# BALLINA FLOOD RELIEF SCHEME PUBLIC CONSULTATION EVENT NO. 2

MGW0290  
Ballina Flood Relief Scheme Public  
Consultation Event No. 2  
S6.P01  
10 July 2023

**REPORT**

## Moy Proposed Flood Defence Options

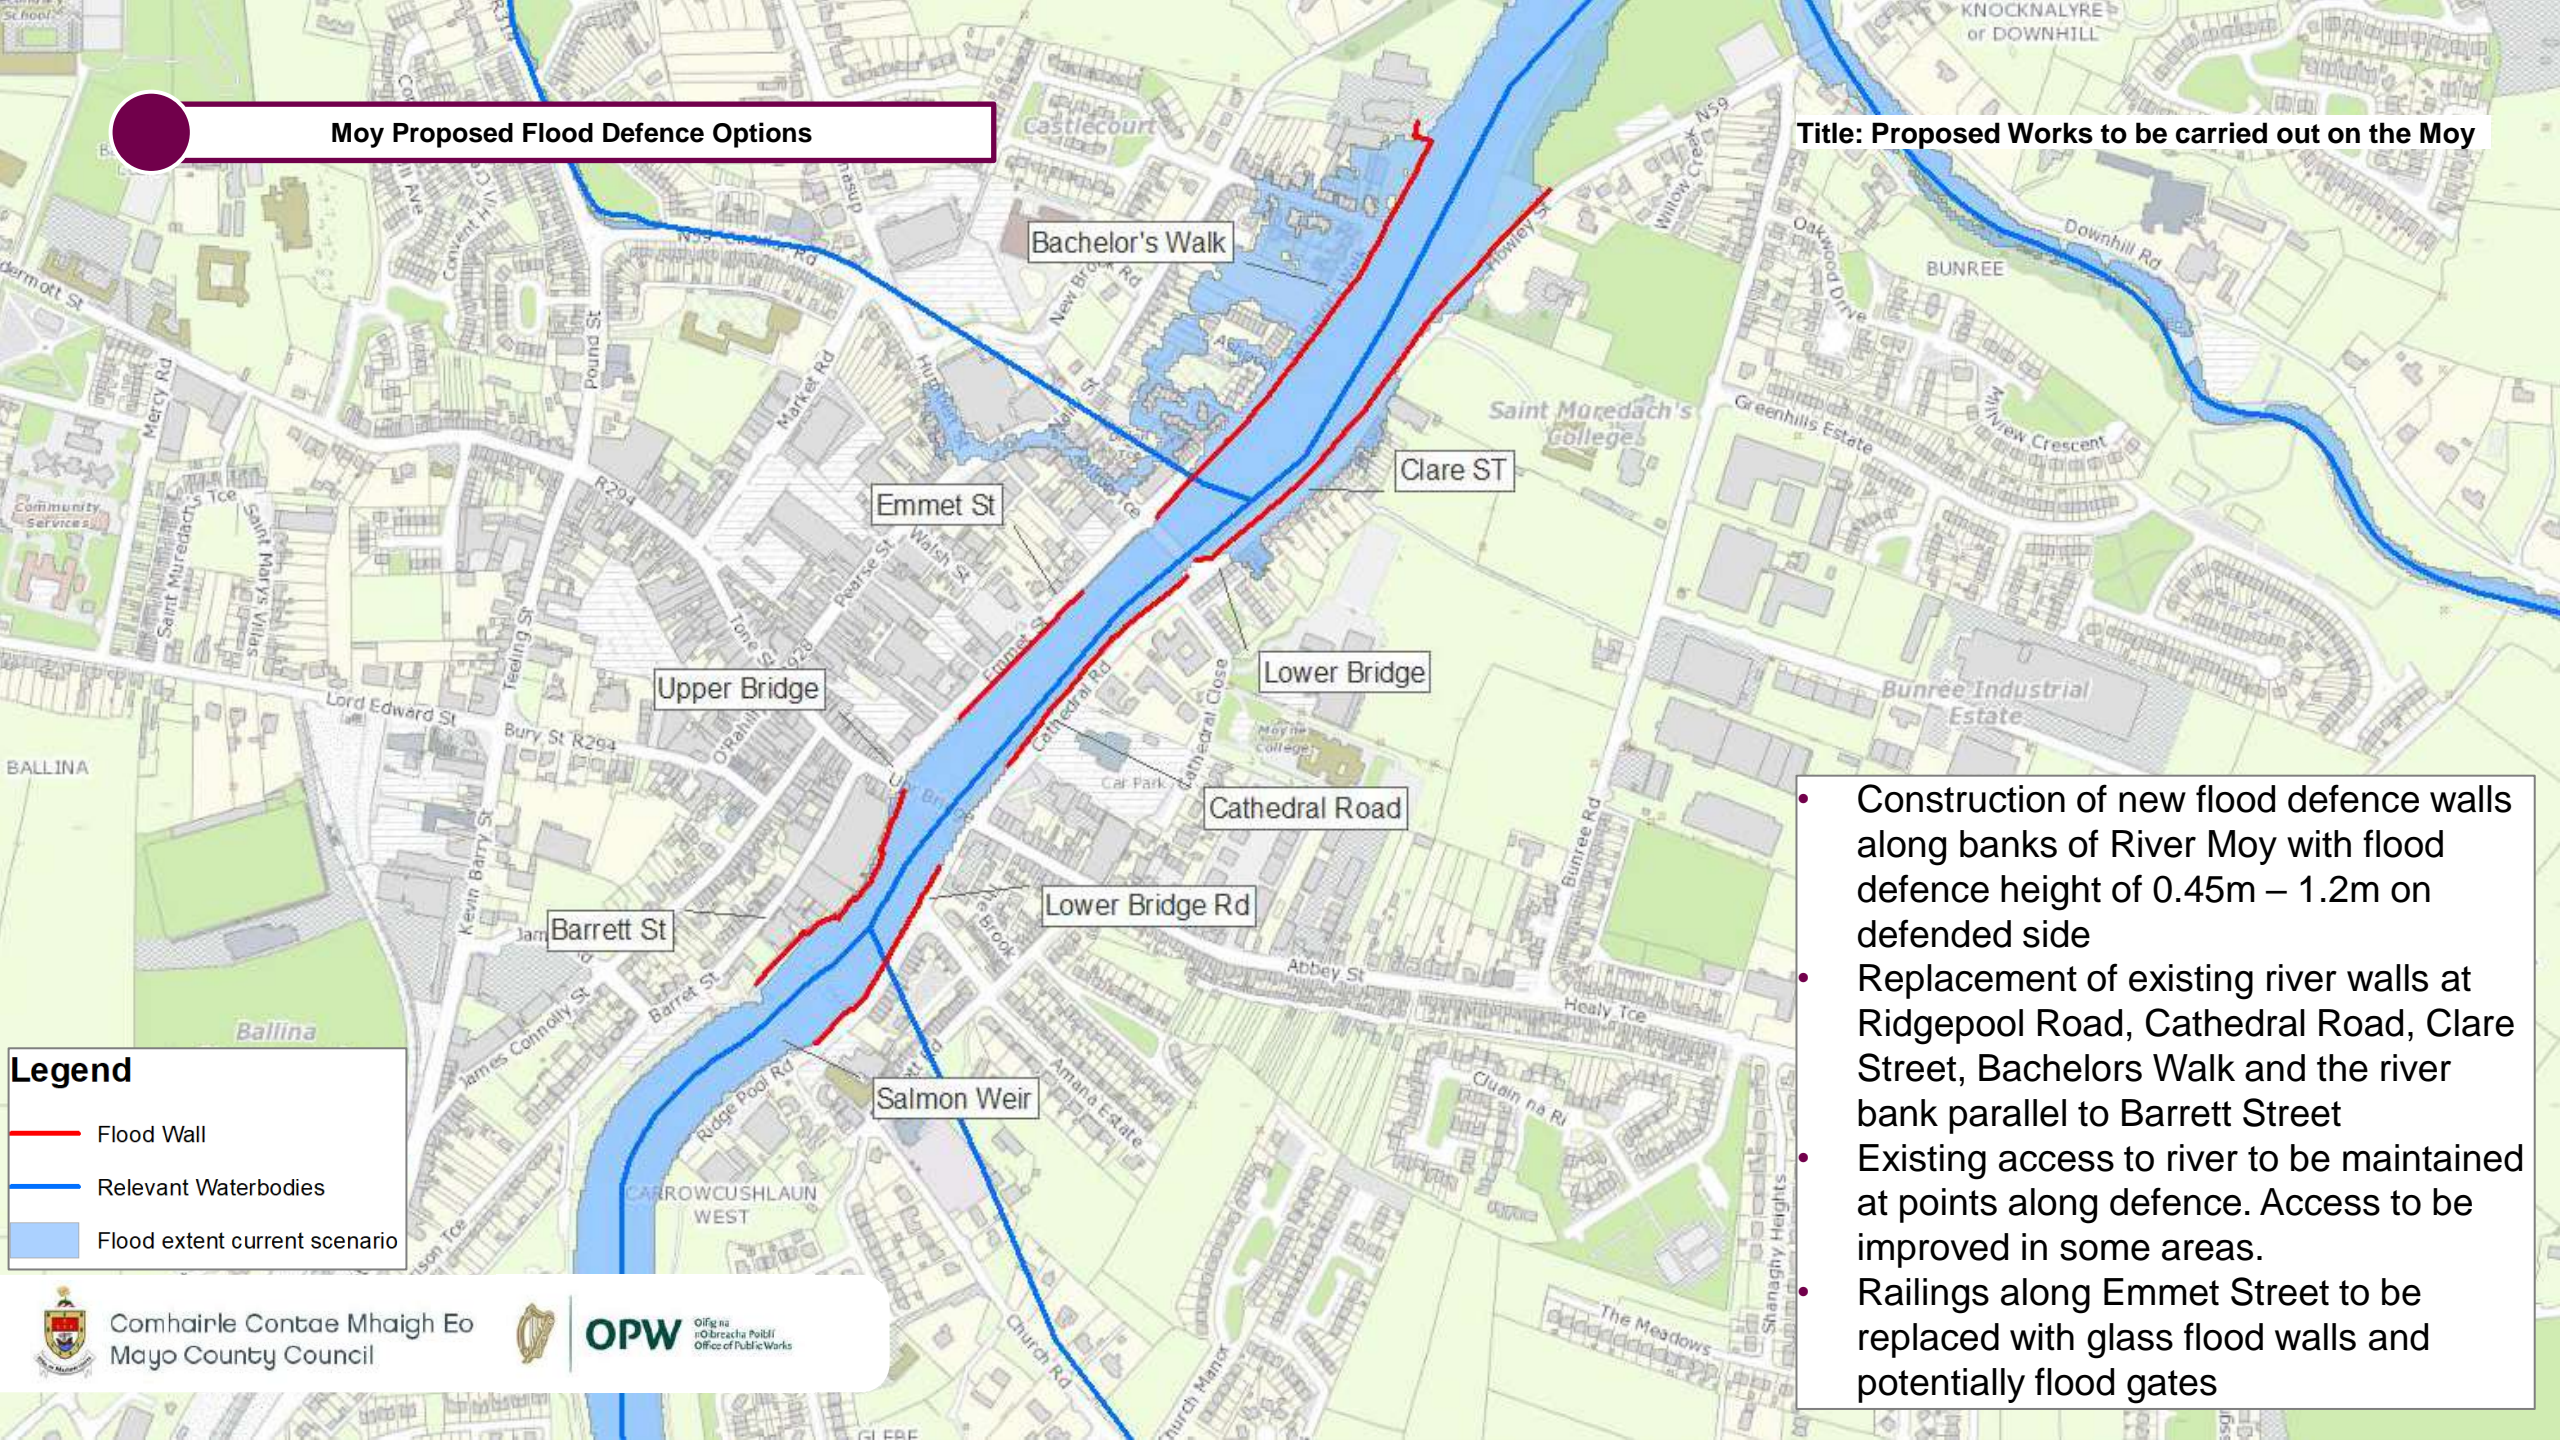
6. River Moy - The proposed flood walls must not prevent access for anglers to the fishery. Pedestrian access to fishery along Bachelors walk and Clare St must be maintained. IFI intends to install a disabled access for angling at the downstream end of the proposed wall on Clare St. and this must be facilitated in the design. Pedestrian and vehicle/boat access to the River Moy must be maintained from Cathedral Road. IFI launch protection vessels from this location which is also utilised by the emergency services and recreational users. Pedestrian and disabled access must be maintained at the ridge pool upstream of the upper bridge, this access is critical to the functioning of the fishery. IFI request that the proposed wall does not exceed the existing rail height at this location. There is also potential to introduce angler access adjacent to the salmon weir on Ridge Pool Road as part of the proposed works. This would improve safety for anglers accessing the fishery. Three, currently unused, pedestrian access points to the fishery exist along Emmet Street. The proposed works must not prevent this access being redeveloped along this stretch in the future. The timing of the proposed works will have a significant impact on the operation of the fishery. While instream works in spawning and nursery areas is limited to between July and September inclusive, to protect spawning and juvenile salmonids this is not the case in the lower section of the River Moy. IFI request that work on this

section of the River is limited to the end of September where coffer dam installation is required through to the first of the following April when the coffer dam must be removed to facilitate angling along this valuable stretch of river.

## Quignamanger Proposed Flood Defence

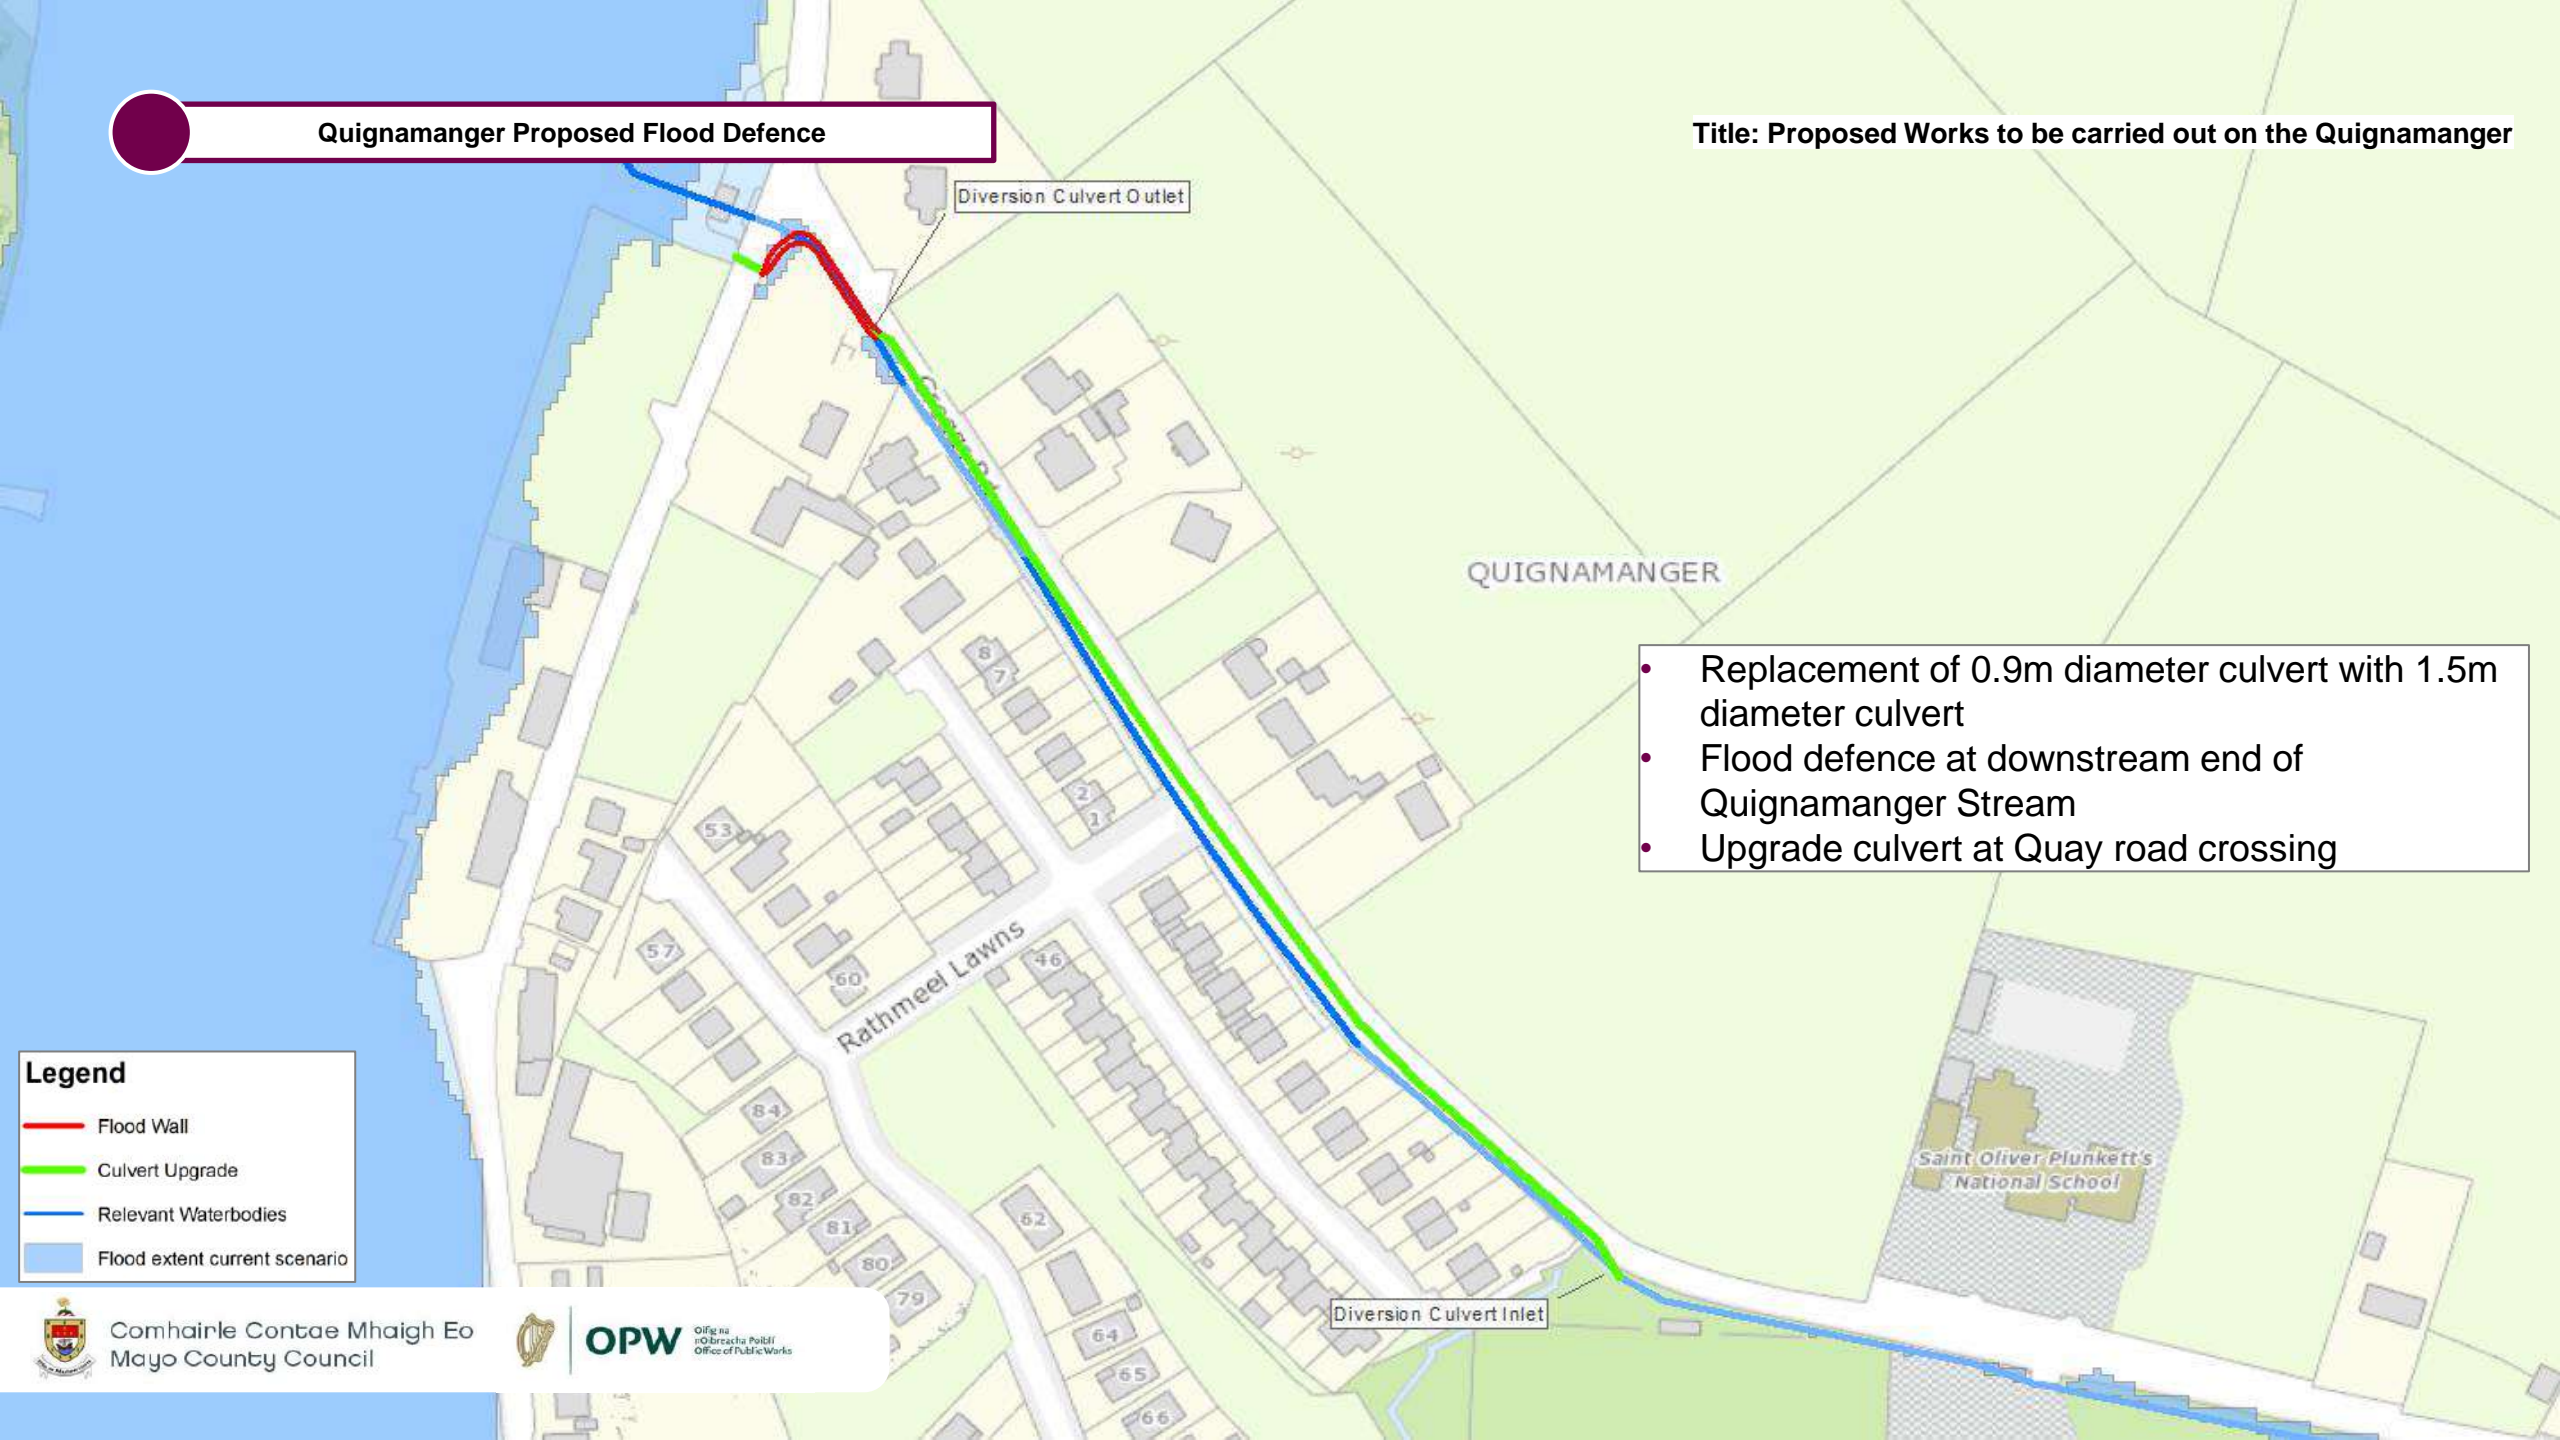
8. The Quignamanger Stream provides habitat which maybe suitable for eel. The existing culvert under the Quay road is a barrier to fish movement and impedes water flows in flood conditions. The proposed culvert upgrade must include a replacement culvert which provide passage for any aquatic species present. A significant proportion of the flow within this channel appears to come from a surface water drainage connection approximately 40m upstream of the Quay road culvert. IFI request that all exiting open channel is retained and existing culverts which restrict flood flows and or fish passage are replaced with adequately designed culverts. All the existing open channel must be retained as open channel. The area immediately upstream of the Quay road culvert could be redesigned to facilitate flood flows. This could be done by reprofiling the surrounding area to include a swale or other nature-based solution to accommodate flood flows which will not be facilitated by the culvert upgrade.
